Project Name: 9101 Highland
 Description: Revised preliminary site plan approval recommendation
 Date on Agenda this packet pertains to: January 16, 2025

RE: 9101 Highland Road-Proposed Commercial Development- Preliminary Site Plan Review – 3rd Review

**Preliminary Site Plan / Special Land Use Review
for
White Lake Charter Township, Michigan**

Applicant:	Affinity 10 Investment, LLC
Project Name:	9101 Highland Road
Plan Date:	July 24, 2024
First Revision Date:	October 17, 2024
Second Revision Date:	December 20, 2024
Location:	South side of Highland Road (M-59), West of Sunny Beach Boulevard. Parcel ID: 12-23-227-003
Action Requested:	Preliminary site plan and special land use review

SHEET + NUMBER
A-302

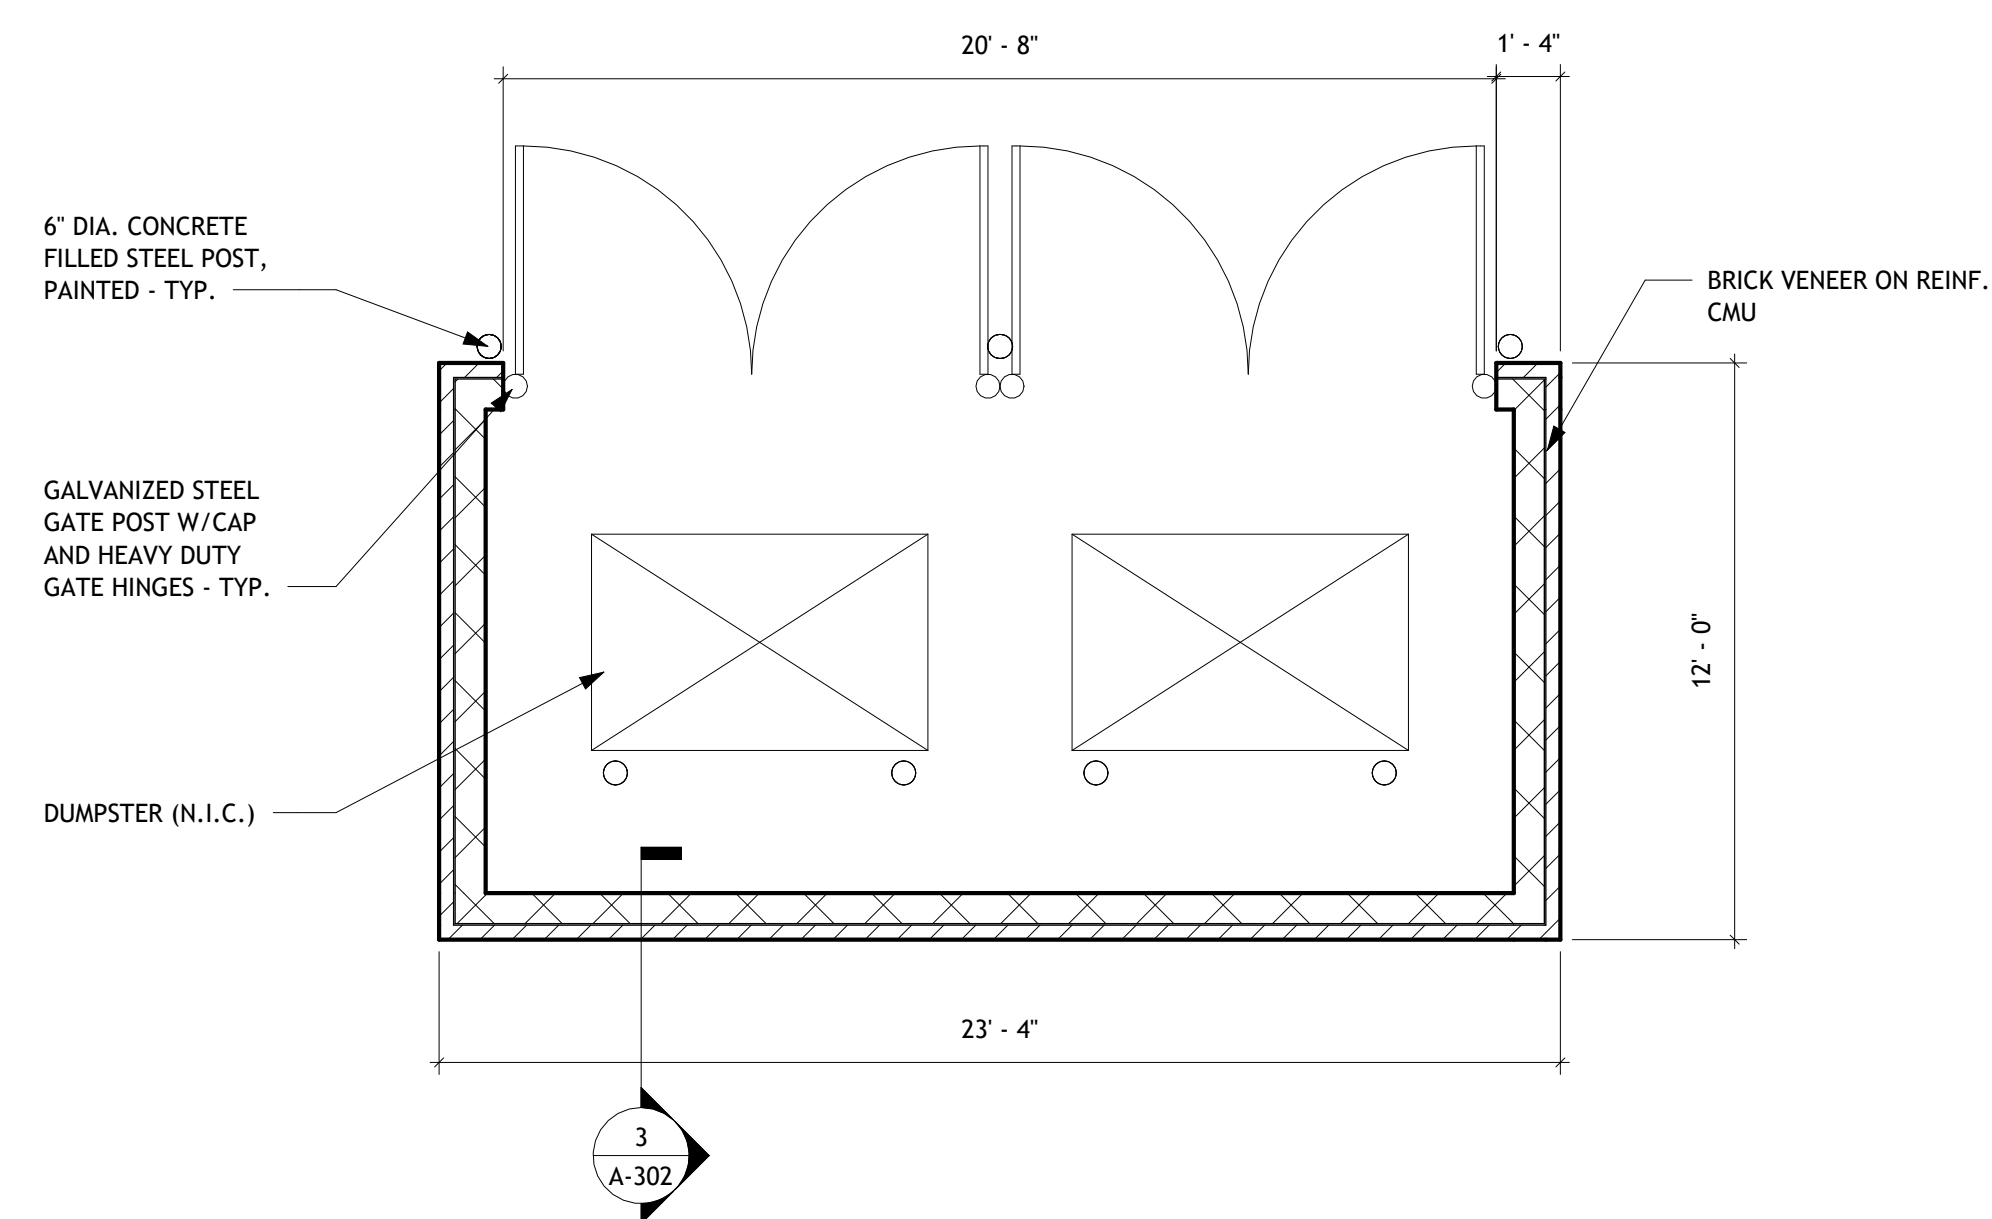
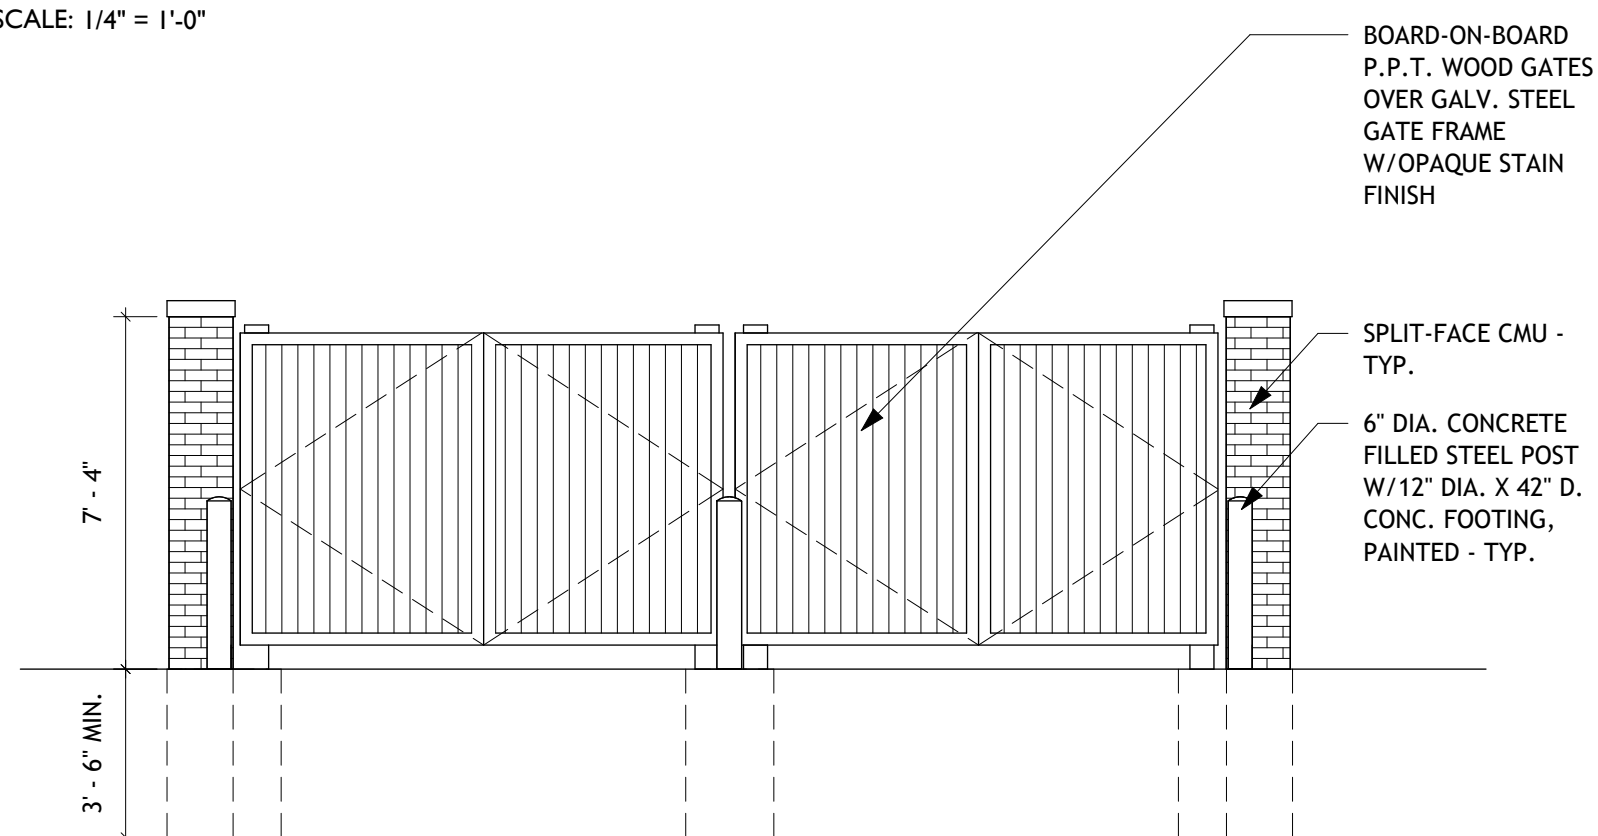
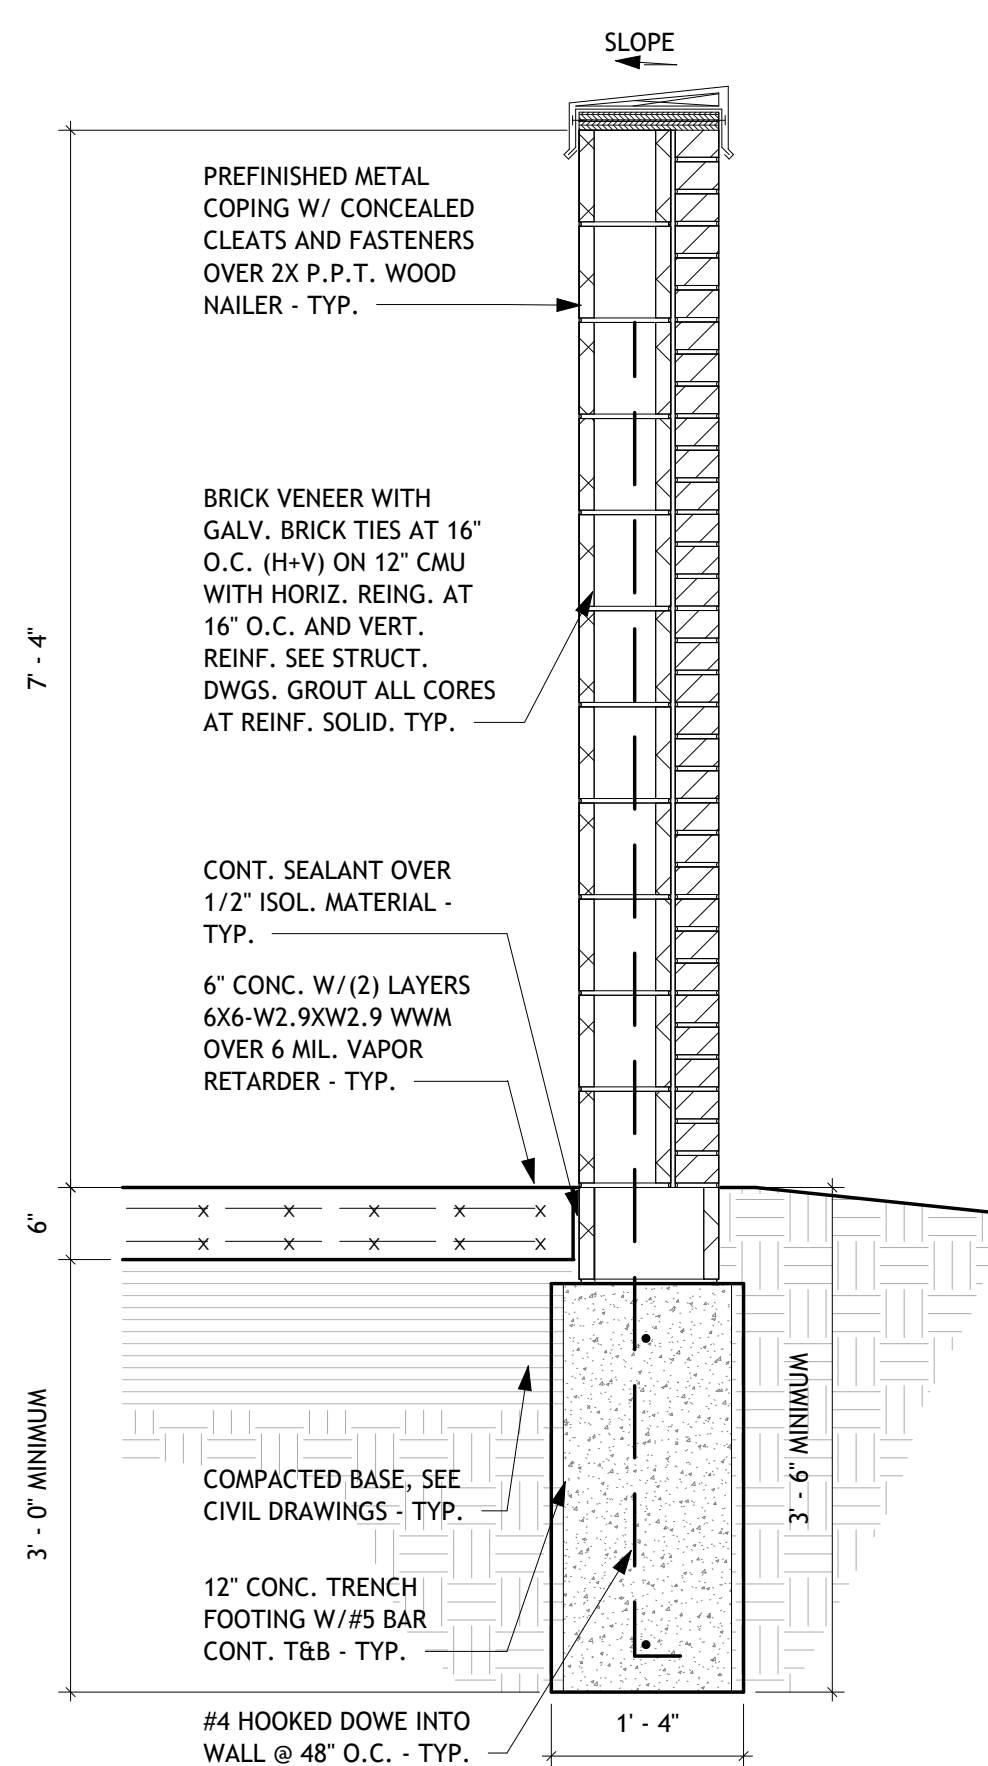
Trash enclosures are to be constructed of similar materials as the principal structure on the site. Brickform concrete or stained, decorative CMU block may be permitted where the principal building is not masonry, however, plain CMU block is not allowed. Details on Sheet C-13 indicate enclosure walls are constructed of split face block CMU but do not indicate a staining or decorative treatment. Sheet A-302 provides enclosure details that reference enclosure walls as CMU and gates materials as stained wooded with a metal frame. The applicant should remove the trash enclosure detail from Sheet C-13 and clarify the CMU enclosure wall decorative feature on Sheet A-302 for final site plan.
